TCAS in TA ONLY: intruders shown as TAs

Aircraft	A32NX and A380X
Where to find it	ND traffic display; TCAS mode on the A32NX TCAS panel / A380X SURV CONTROLS
PR branch	pr/07-tcas-ta-only-intruder-level (independent)
Status	Tested in the sim (September 2026).
Pictures	Captain NDs in the local browser harness, running the builds installed in the sim; the symbol legend is a drawing (the harness has no traffic).

Figure 2. A32NX: TA ONLY, centred at the bottom of the ND (A320 FCOM DSC-34-SURV-60-20 figure).

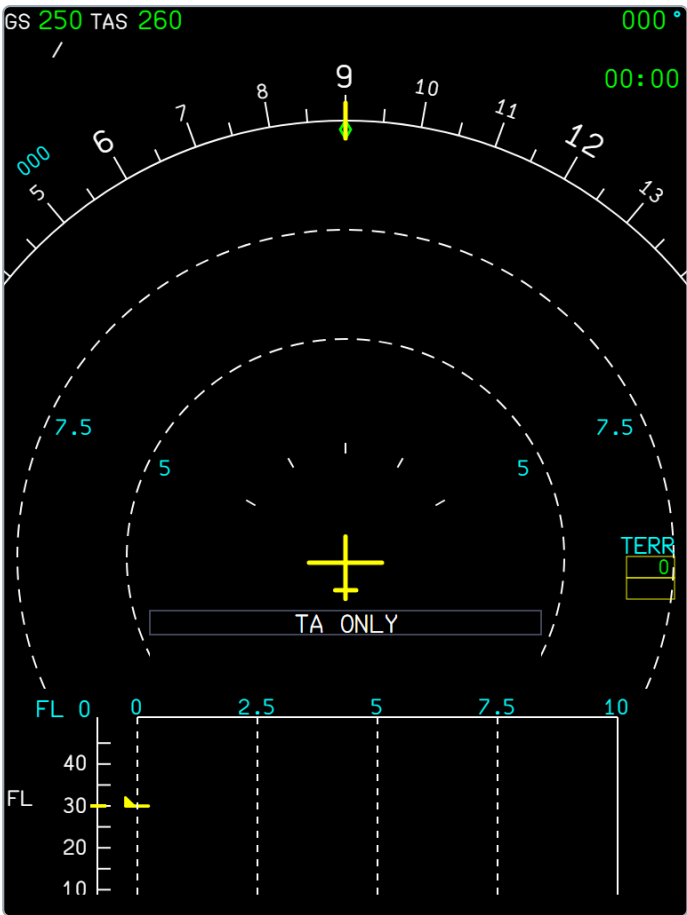
While resolution advisories are inhibited, an intruder that would be an RA is shown and announced as a traffic advisory; the TA ONLY message is centred on the A32NX ND as in the FCOM

With every RA inhibited (TA ONLY selected, or below 1000 ft radio altitude), the TCAS kept classifying an intruder that met the RA criteria as an RA. The ND drew it as a red RA square, and since it was not a TA, there was no "TRAFFIC, TRAFFIC" and no TA state. A real TCAS in TA ONLY shows it as an amber TA with the TA aural. The classification is now capped at TA while all RAs are inhibited.

Situation	What you should see
TA ONLY selected, intruder meeting the RA criteria	Amber TA circle and "TRAFFIC, TRAFFIC" (before: red RA square, no aural).
Below 1000 ft radio altitude (all RAs inhibited)	Same: TAs only, TA ONLY on the ND.
Partial inhibits (no CLIMB / DESCEND / INCREASE DESCENT RA)	Unchanged: RAs are still issued.
An RA already running when the inhibit starts	It runs to its own end.
